Subject: Proposed Silesia Properties, L.P. Permit No. WQ0015835001

I am submitting these comments on behalf of the Greater Edwards Aquifer Alliance regarding the Texas Land Application Permit (WQ0015835001) proposed for Silesia Properties, LP. The proposed permit would authorize wastewater treatment and subsurface drip dispersal system disposal for 0.365 million gallons per day into the Honey Creek watershed upstream of the Honey Creek State Natural Area.

My comments are based on information provided by the applicant and on the draft wastewater permit as revised, February 3, 2020. My opinions are also founded upon my education, experience and engineering expertise in water resources, surface and groundwater hydrology, pollutant fate and transport, as demonstrated in my resume in Attachment 1.

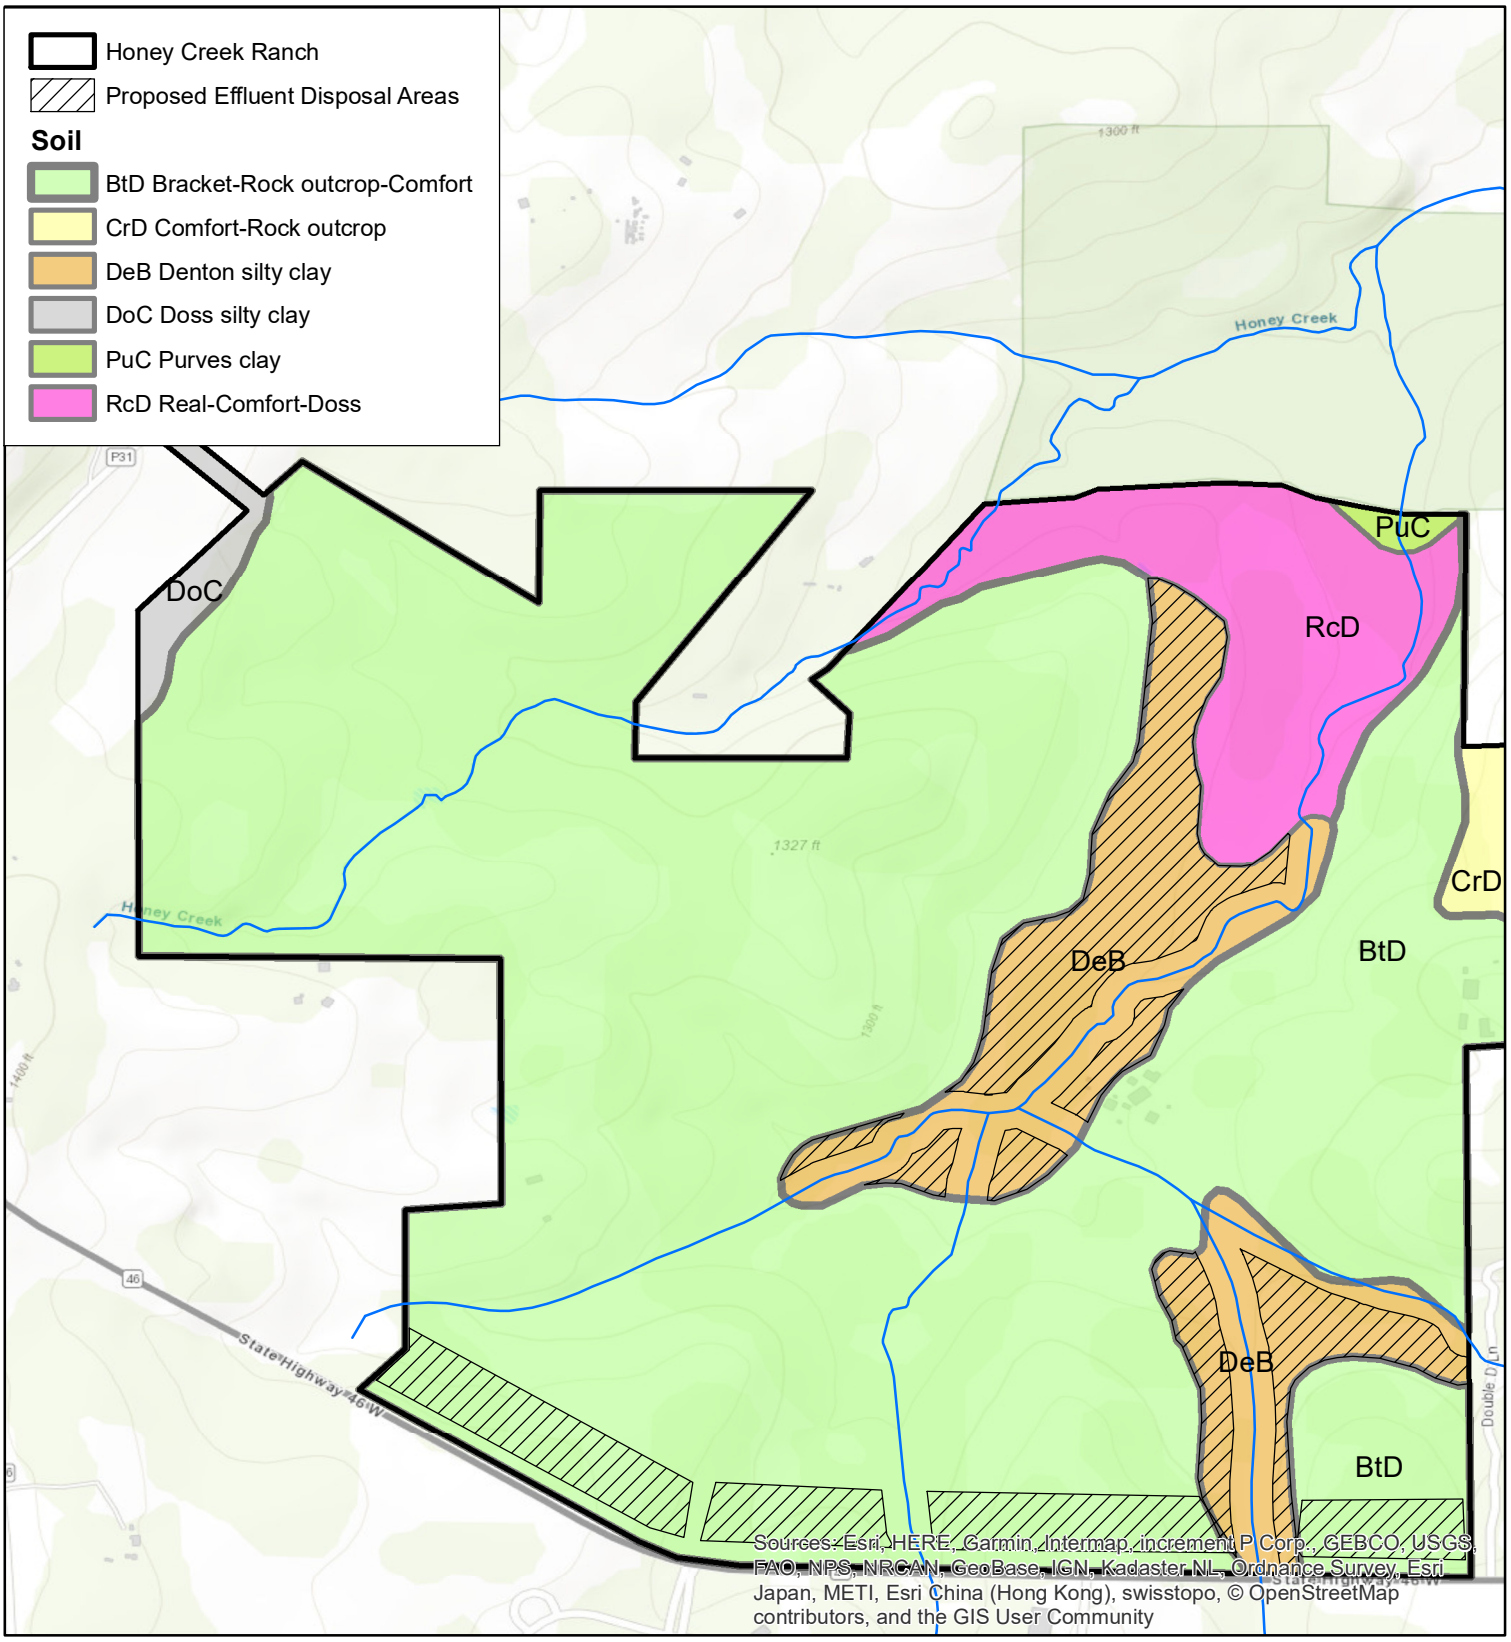
My preliminary calculations indicate that effluent ranging from about 10 percent to 30 percent of the proposed effluent volume, on an annual basis, would not be accommodated within the proposed storage volume and disposal area without oversaturating soils. Based on my preliminary modeling, wastewater effluent would exceed the proposed system capacity by at least 69 day and up to 157 days in each of the 61 years from 1954 to 2014.

The total volume of excess effluent over this 61-year period would be 1.8 **billion** gallons. Twenty-two percent of the proposed effluent volume proposed in the permit would be either irrigated onto saturated soils or else pumped and hauled to another treatment facility.

The proposed 84-acre effluent disposal area would be sufficient to dispose of 150,000 gallons per day of effluent, without over-saturating soils, if effluent storage was increased to 8.5 million gallons.

Figure 8. Soil Suitability for Subsurface Drip Irrigation

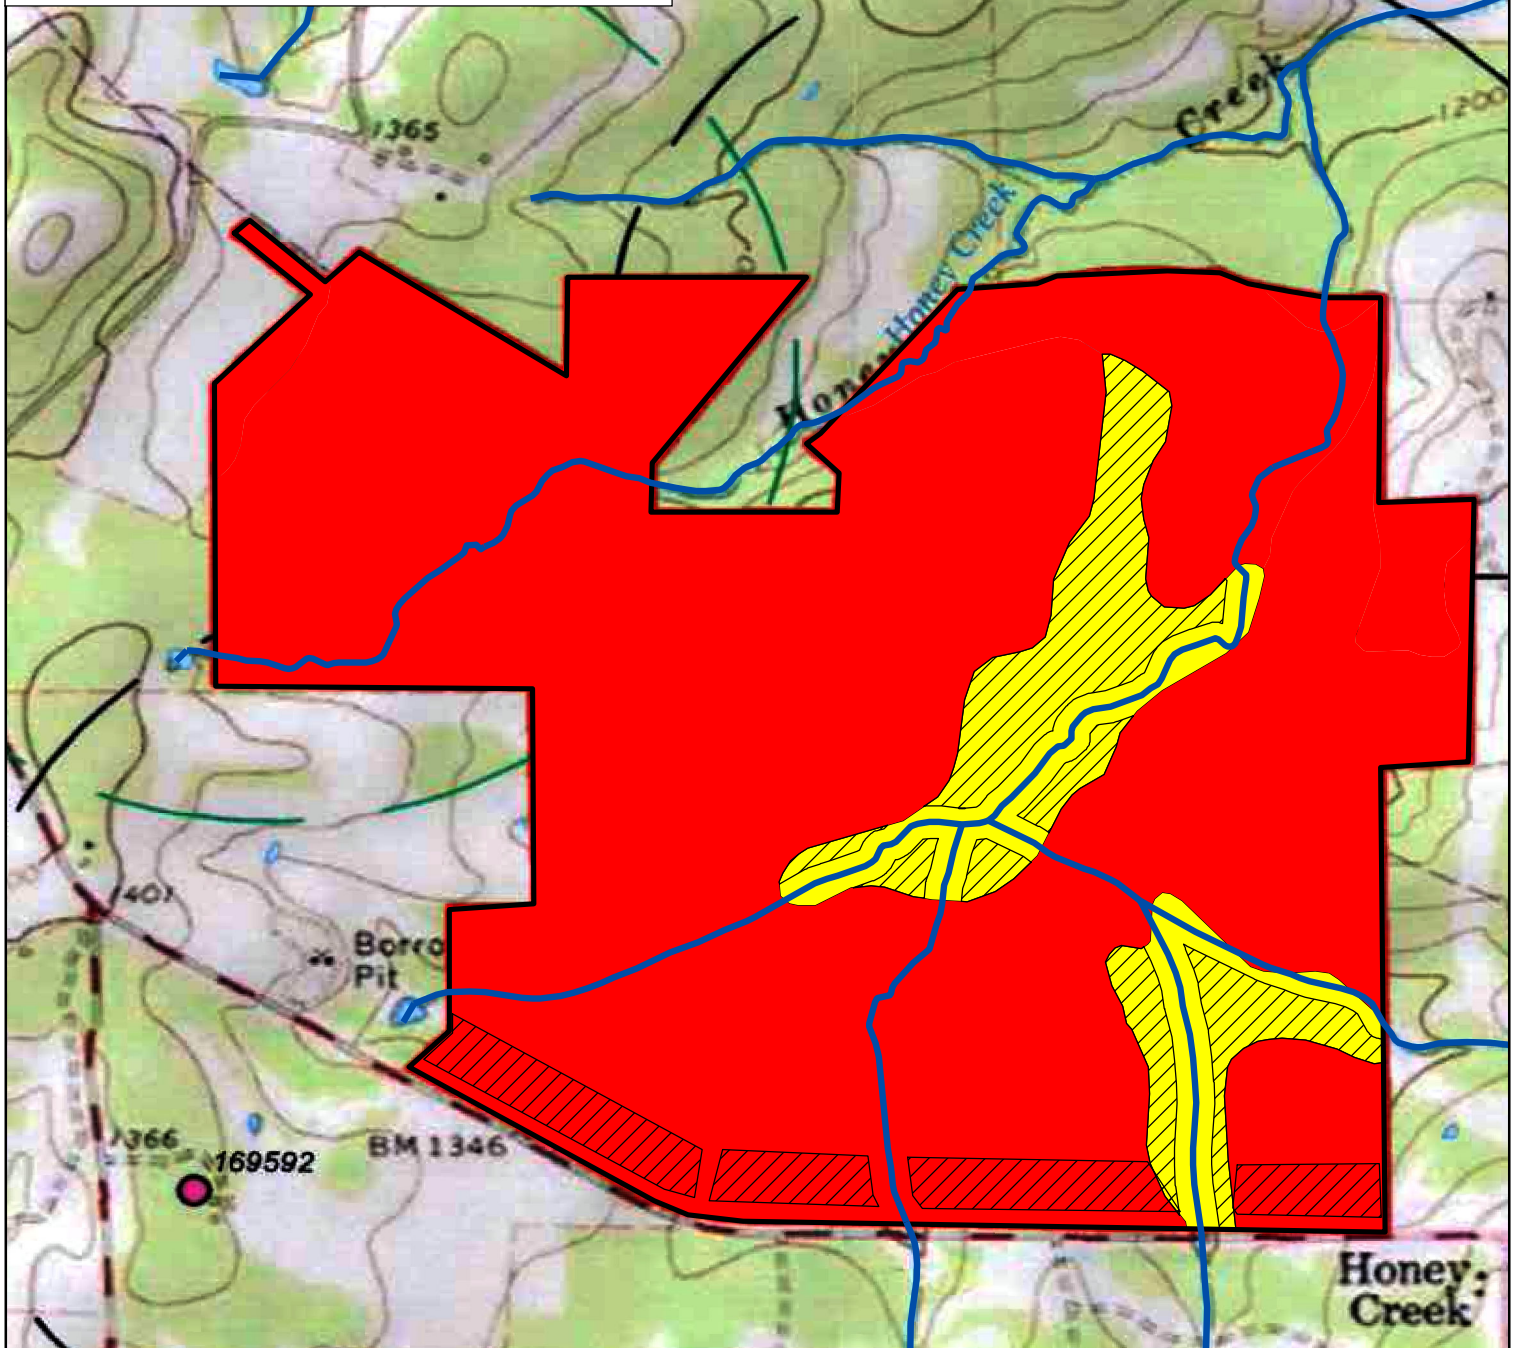
Soils on Honey Creek Ranch proposed for irrigation are also described by the Natural Resources Conservation Service as shallow, with soil depths of less than 20 inches. Because of these shallow depths, the Natural Resource Conservation Services has described all of the proposed disposal area soils as either very limited or somewhat limited for subsurface drip irrigation, as shown on Figure 8. Some of the area proposed for effluent disposal includes rock outcrop over which soil depths would be essentially zero.

All of the 46.3 acres within Honey Creek Ranch that are not **very limited** for sewage effluent drip irrigation have been proposed for sewage effluent disposal. An additional 37.7 acres must be on soil identified by the U.S. Natural Resources Conservation Service as “very limited” for that purpose.

Figure 9. Wetlands

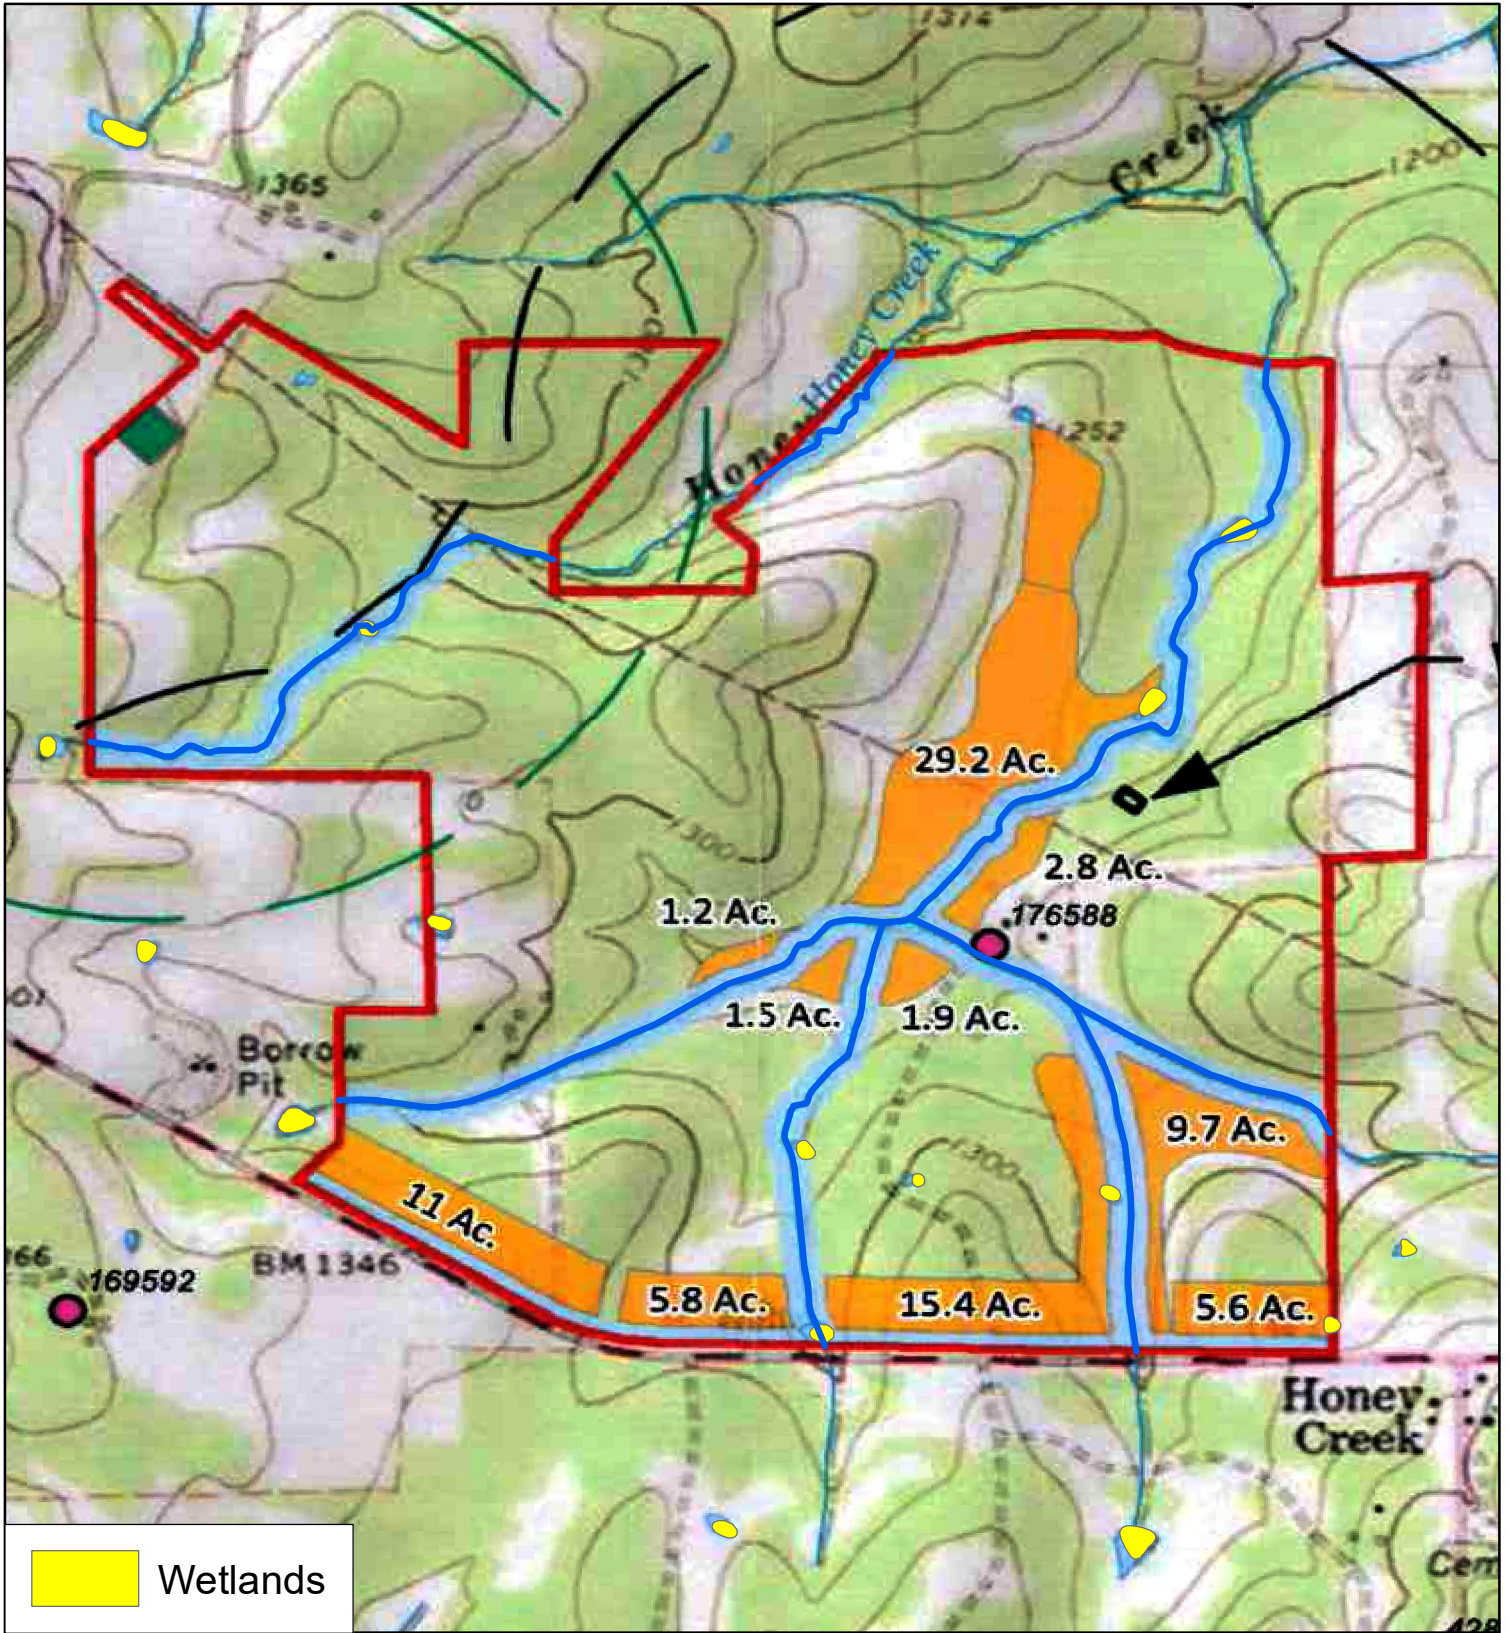
The database of Texas wetland areas includes eight freshwater ponds and one freshwater emergent wetland within Honey Creek Ranch, as shown on Figure 9.<sup>11</sup> Three of these features are within, adjacent to, or downstream from proposed wastewater effluent disposal areas. The proposed permit fails to protect these sensitive wetland features.
